Wichita-Sedgwick County Metropolitan Area Planning Department

May 31, 2019

Re: **BZA2019-23: City Administrative Adjustment to reduce the north side yard setback of the Compatibility Standards for building and site design in "LC" Limited Commercial zoning adjacent to "SF-5" Single-Family Residential zoning.**

BUILDING SETBACK VARIANCE EXHIBIT

1 BUILDING SETBACK VARIANCE EXHIBIT

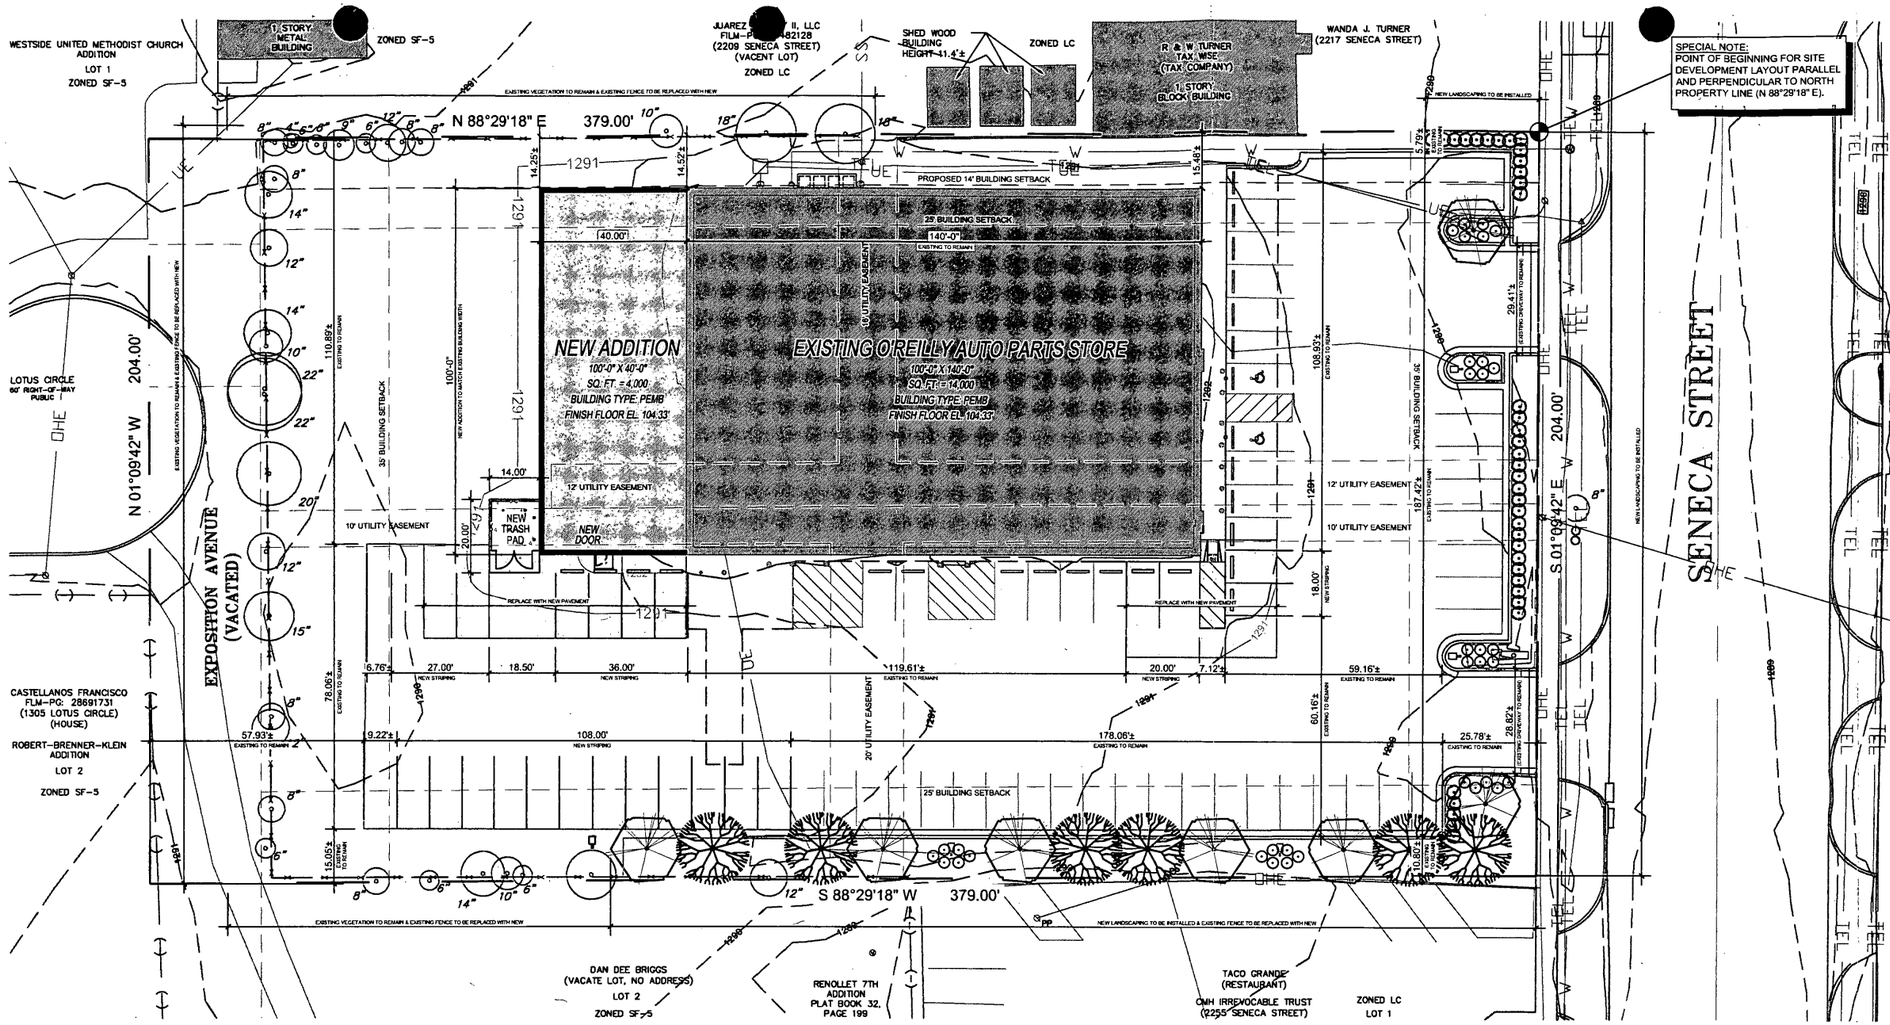
We reviewed your request for an Administrative Adjustment to reduce the Compatibility Standards on the north side yard setback [Sec IV-C.4] from 25 feet to 14 feet to construct a 40-foot by 100-foot building addition, as shown on the submitted site plan.

Section V-I.2.d of the Unified Zoning Code allows an Administrative Adjustment to reduce or waive the required compatibility setback. We find that reducing the north side yard compatibility setback as proposed, meets the four criteria required by Section V-1.6 as set out below:

1) Impact on safety and convenience of vehicular and pedestrian circulation: The reduction of the compatibility setback should have no impact on the safety and convenience of vehicular and pedestrian circulation in the vicinity as right-of-way and driveways are not affected.

2) Impact on existing uses in surrounding areas: There will be no impact on the existing uses in surrounding areas as a result of the north side yard compatibility setback reduction; landscape buffering will be required per the City of Wichita Landscape Ordinance.

3) Compatibility with existing or permitted uses on abutting sites: The compatibility setback reduction with the landscape buffering separating the property on the north, will be compatible with existing and permitted uses on abutting SF-5 zoned site.

4) Effect on public health, safety or welfare: There will be no encroachment into public utility easements or right-of-way. There should be no impact on the public health, safety or welfare nor will properties or improvements in the vicinity be materially injured.

Our signatures below indicate that an Administrative Adjustment to reduce the north side yard building compatibility setback from 25-feet to 14 feet is hereby granted, subject to the following conditions:

1) The site shall be developed in general conformance with the approved site plan and the City of Wichita Landscape Ordinance.

2) The adjustment shall apply only to the north side yard compatibility setback as illustrated on the approved site plan. All other structures or additions on the subject property shall conform to the locations and setbacks permitted by the Unified Zoning Code unless a separate Zoning Adjustment or Variance is granted.

3) The applicant shall obtain a permit and complete all improvements within one year of the Administrative Adjustment approval. The site shall conform to all codes including but not limited to building, health and fire.
